Annex-1 : Effective top of the head restraint

Case study of IP point determination at the horizontal top

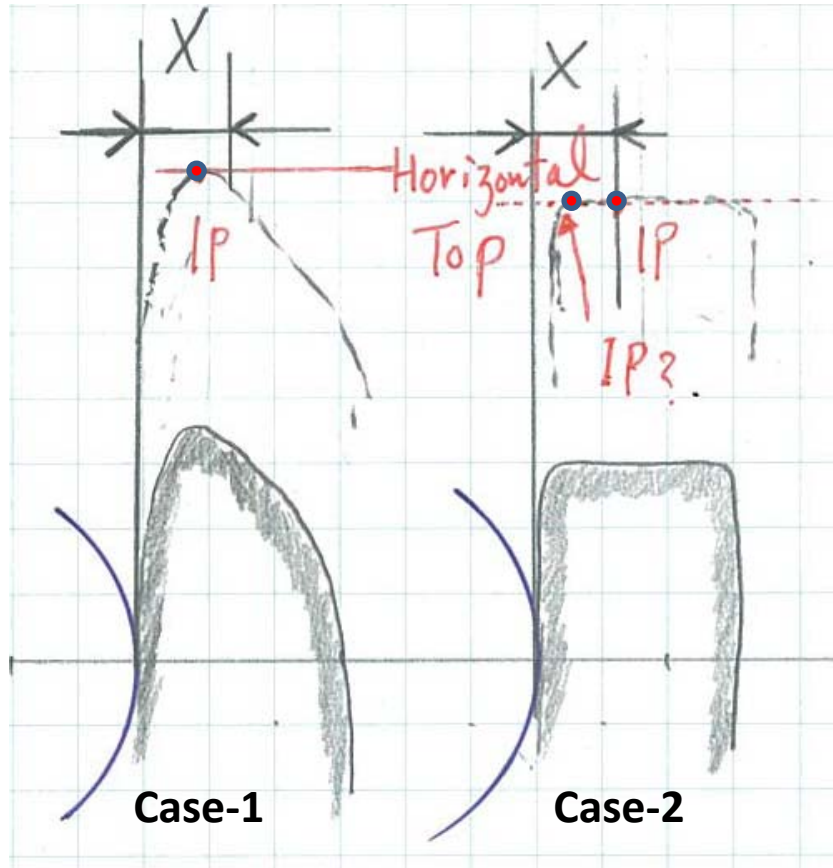
Where IP Would be located rearward of the horizontal top of the head restraint, IP will be designated at the horizontal top of the restraint (see Figure 1-4)

Case-2 : Horizontal top at the distance X or forwardmost point in horizontal top.

Paragraph 2.3.2 describes that IP would be located rearwards of the horizontal top of the head restraint, IP will be designated at the horizontal head restraint.

Case study of IP point determination where CP can not be determined on the head restraint surface.

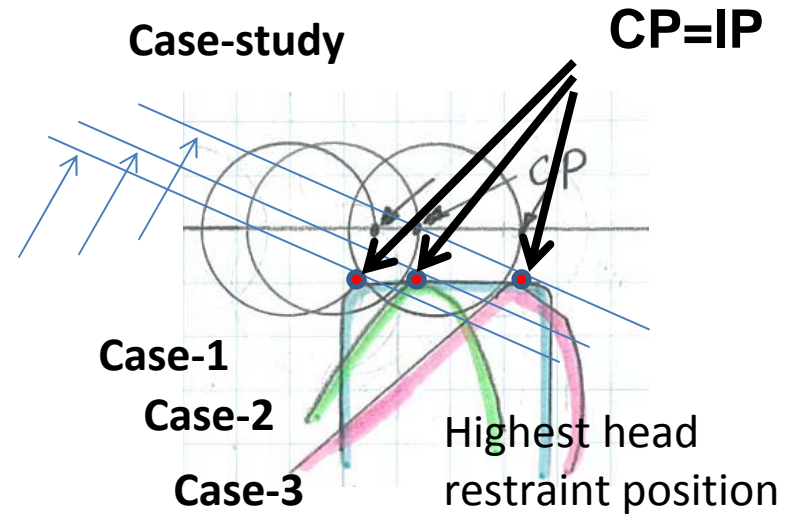
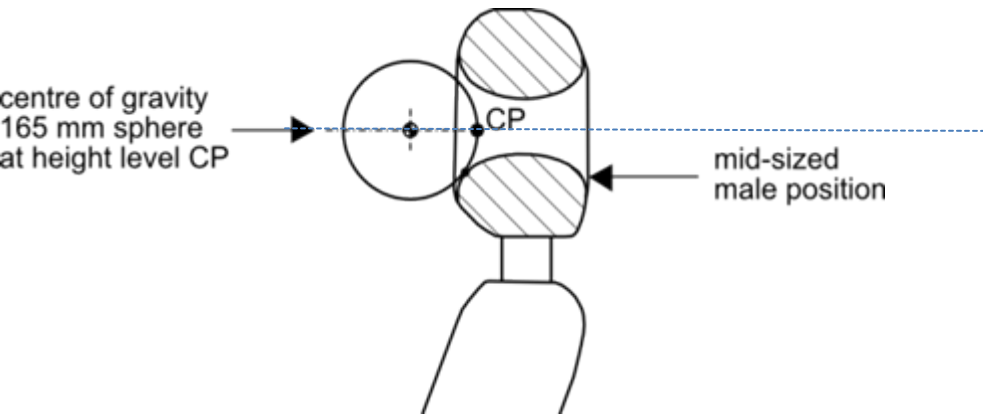
Clarify the effective height of Head restraint

Case-1 to 3 : Paragraph 2.3.2 describes that CP is determined as horizontal top

Paragraph 2.3.2 describes that IP would be located rearwards of the horizontal top of the head restraint, IP will be designated at the horizontal head restraint.
